Make	Model	Year	Install	ECU	Lights	Locks	Trunk/Hatch	I/O Changes
DL-TL6 Toyota	Camry Hybrid PTS AT	2012-17	Type 3	2/DKP	Park / Auto Yes	No	No	Green White/Blue X

FTI-TLP4: Installation and Configuration Notes

Overview: Mis-Wired door lock connector, field repair required.

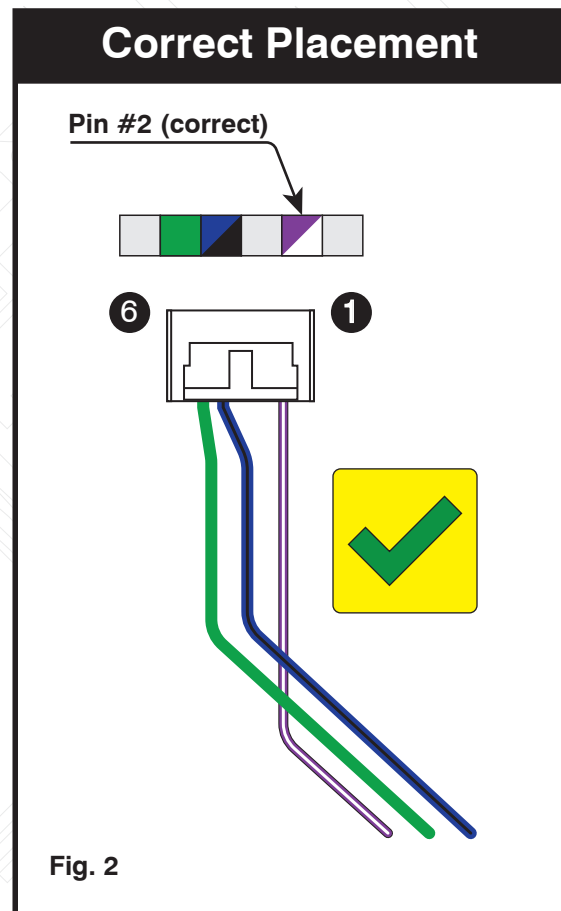
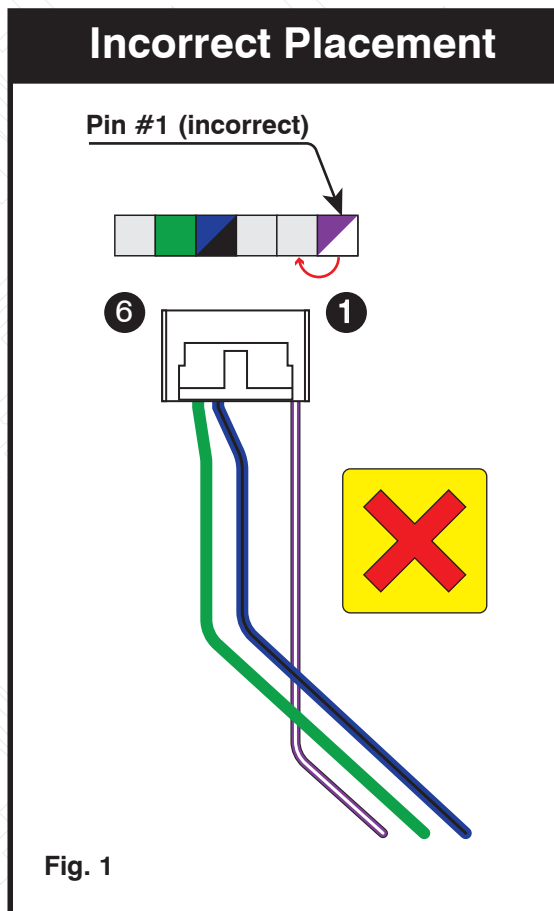
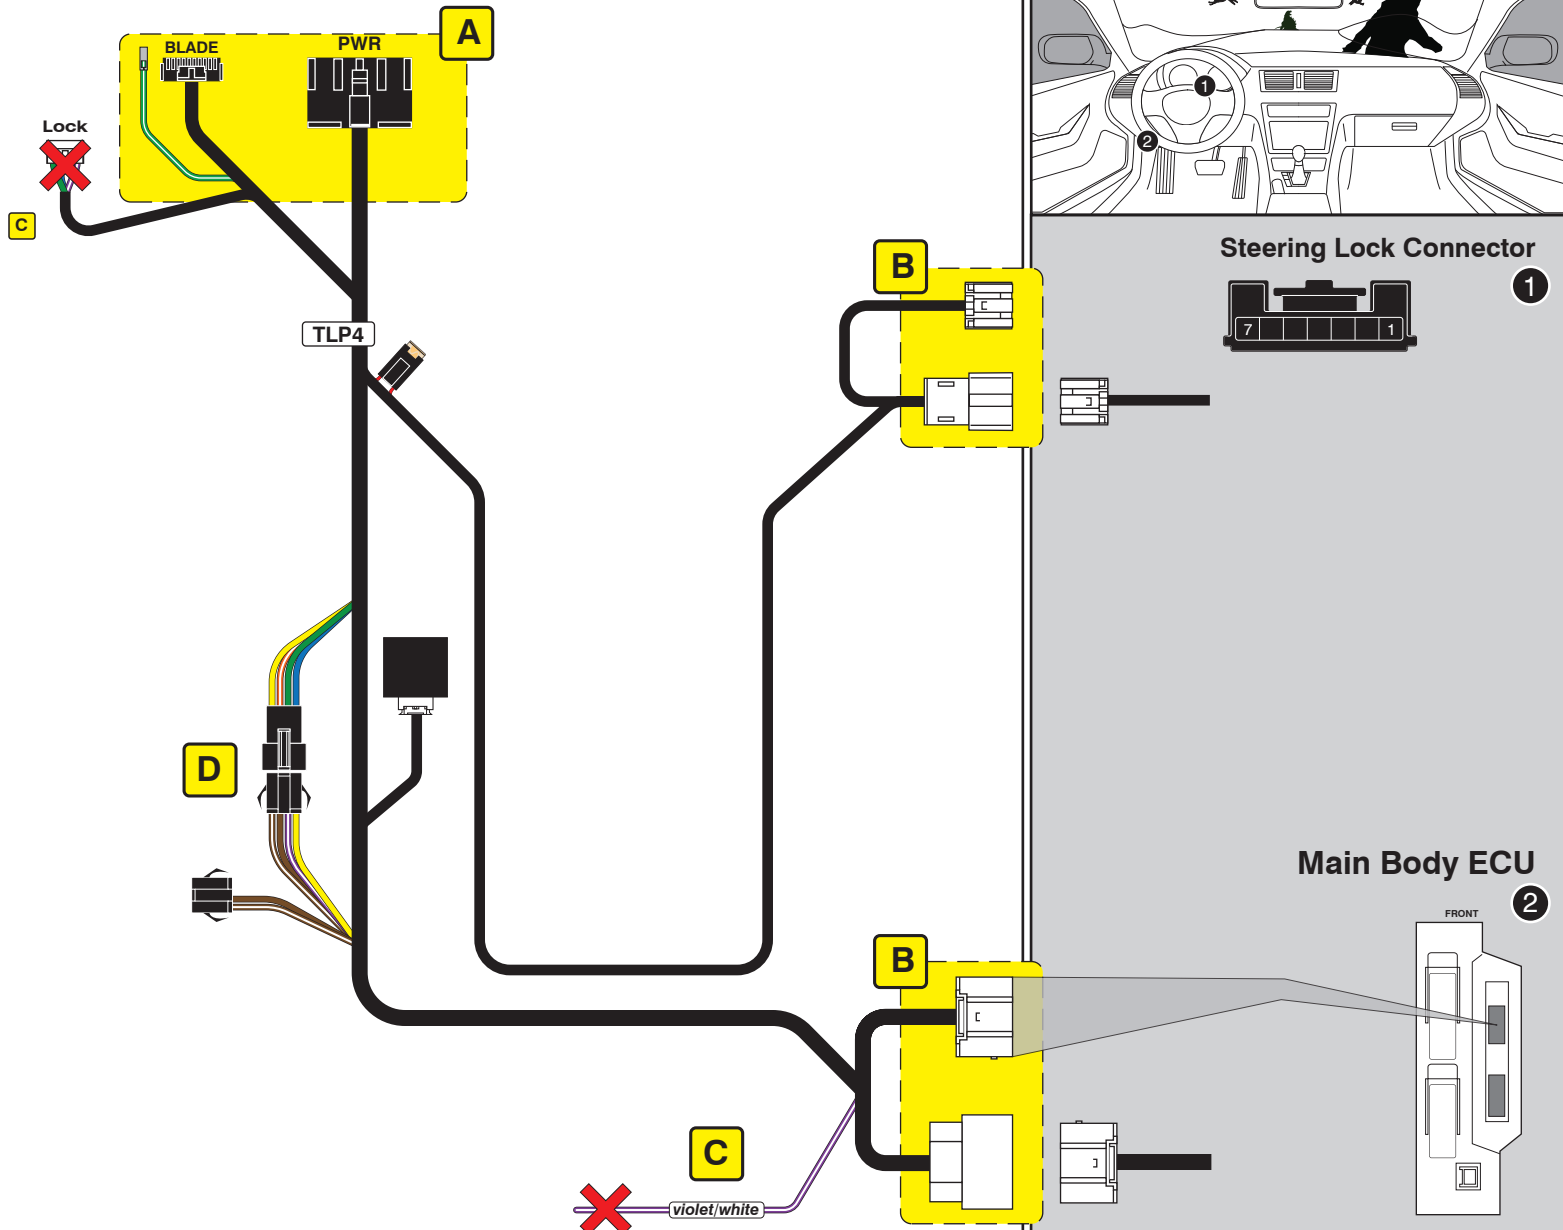
Issue: A review of the latest samples of **FTI-TLP4 T-harnesses** has revealed a misplaced trunk output wire in the 6-pin Lock Accessory Connector requiring that the wire be relocated to the correct position, to ensure safe operation when used. **Using the harness without addressing the issue will result in failed trunk/hatch control, and possible damage to the vehicle BCM.**

Correction: The harness purple/white wire in the latest production run of FTI-TLP4 harnesses has been inserted in the position normally used for the +12V power connection in the accessory harness. Before completing the installation, the installer must relocate the harness purple/white wire to the correct position, 1 space inward on the 6-pin connector, see illustrations below in Fig. 2.

To relocate the terminal, using a fine pick or Olfa type knife, depress the terminal locking barb and pull the purple/white wire from the connector housing. Once the terminal has been removed from the housing, again using the pick or knife, lift the locking barb about 1/16" (1.5 mm) and reinsert the terminal in the correct position. If upon initial examination of the harness the lock accessory connector looks like the illustration in Fig. 2, no modification is necessary, the wire is in the proper position.
